Subject: Dendrobium Mine Extension Project – State Significant Infrastructure (SSI-33143123) – Advice on Environmental Impact Statement (EIS)

BCD Assessment Summary Dendrobium Mine Extension Project EIS (SSI-33143123)

Detailed BDAR Assessment Dendrobium Mine Extension Project EIS (SSI-33143123)

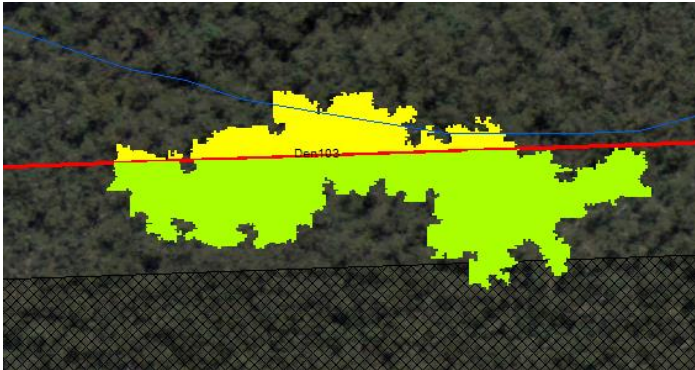
Page 127 Section 3.3.2 Avoid or minimise biodiversity impacts when designing the proposal Table 29	4. Avoidance of subsidence related impacts (prescribed/uncertain impacts) a. The BDAR states the revised project has a reduced layout of 60% and we acknowledge that some measures have been applied to avoid impacts to the dams, 3rd, 4th and 5th order (or above) streams and setbacks from named watercourses. However, the current Project comes with a very high percentage of expected impacts at the surface. The percentage of area within the footprint of the Project where subsidence impacts are expected has not been estimated in the EIS is likely to be far higher (see Attachment C). b. The BDAR does not sufficiently demonstrate that the "avoid" and "minimise" principles have been met. c. In its current form, the proposal is likely to have a significant impact on NSW and Commonwealth-listed water-dependent threatened species and ecological	4a-g. The longwall layout and more considered methods of mining below sensitive attributes should be examined to avoid (or significantly reduce) impacts to CUS and streams in the area. Consideration be given to reducing the width of the longwalls to limit surface to seam fracturing and related subsidence. 4b. Additional information is provided to demonstrate that the

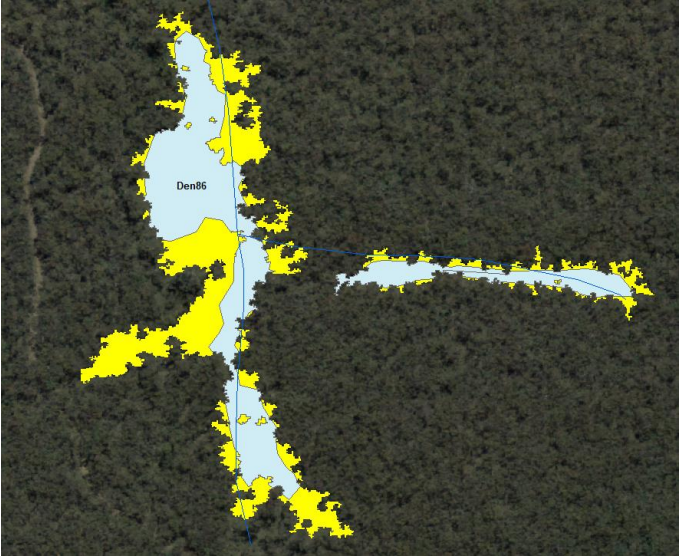
Reference	Issue	Recommendation
	communities including the Coastal Upland Swamps (CUS), the giant burrowing frog and Littlejohn's treefrog. d. The proposal could potentially have a Serious and Irreversible Impact on the giant dragonfly and the broad-headed snake (however further information is required, see matter 9 below). e. A substantial area of the CUS will be impacted by the proposal. While a claimed reduction in area of mining limits impacts, there are still highly significant swamps which will be impacted. Further avoidance is possible and should be examined/adopted to meet BAM requirements. A more sensitive and nuanced approach to mining methods/layouts that prevents seam to surface fracturing and subsequent water loss to swamps is one such approach that warrants detailed examination. f. The BDAR (Table 29) states that prescribed impacts will be avoided and minimised because <i>"all Coastal Upland Swamps would be monitored for potential impacts via a formal monitoring program, and remediation measures undertaken as per the relevant approved management plan"</i>. This does not constitute avoidance and the BC Act clearly requires that impacts must first be avoided before measures to offset or compensate are utilised (BC Act, s.6.4). g. Mining will avoid "key stream features". These are not defined or quantified in the BDAR. h. The BDAR/EIS discounts alternate mine layouts and mining methods based largely on arbitrary Project objectives and problems achieving <i>"complete avoidance"</i>. Alternatives are also discounted on the claim that it is <i>"not considered to be economically viable"</i> but coupled with a principle of maximising access to all the resource/revenue. Alternatives (and associated avoidance) have been considered as an 'all or nothing' proposition which is not the case.	avoid principle has been adequately met as per s 6.4(1). 4g. Define and quantify the term "key stream features" in the BDAR/glossary. 4h. There is the capacity to consider more nuanced or hybrid approaches whereby the current proposal will reduce or limit the predicted subsidence impacts in the more sensitive areas within the vast Project footprint. Assess alternatives that balances a reasonable profit on investment while also reducing the degree of
